SERVICE BULLETIN

SB24-0011

Subject: DCM-271BAH(-OS) High Pressure Switch Change

Old Wiring:

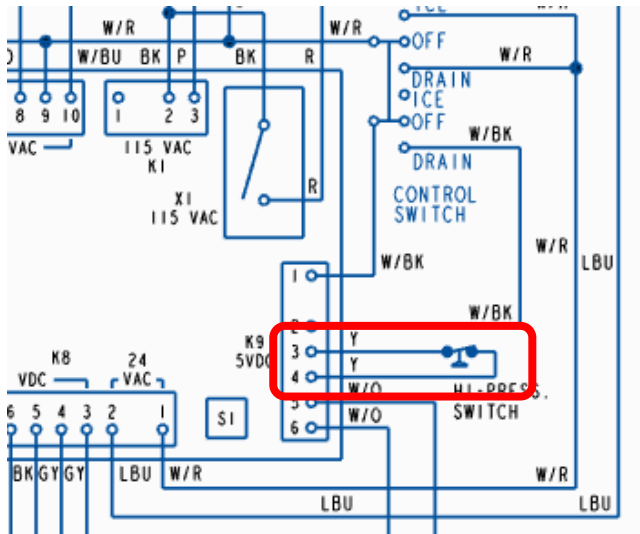
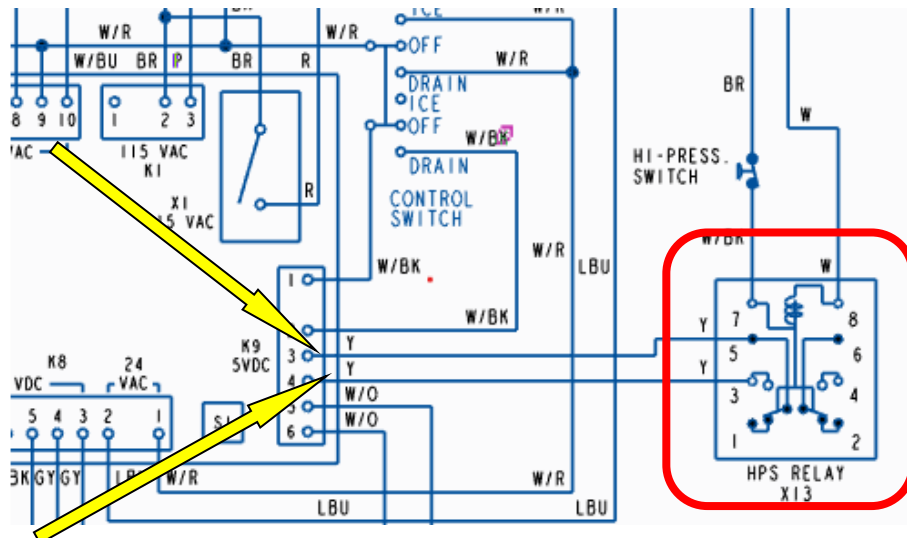
Beginning October 1, 2024, the high-pressure switch for the DCM-271 product, has moved from the 5V DC circuit to the 115V AC circuit.

The high-pressure switch circuit now uses the 115V AC relay contacts to open and close the circuit at the 5V DC to the K9 connector at pins 3&4.

The high-pressure switch part number changed from 4A7070-01 to 463180-04 with relay 418271-03

New Wiring: Pins 3&4 5V DC with new relay added
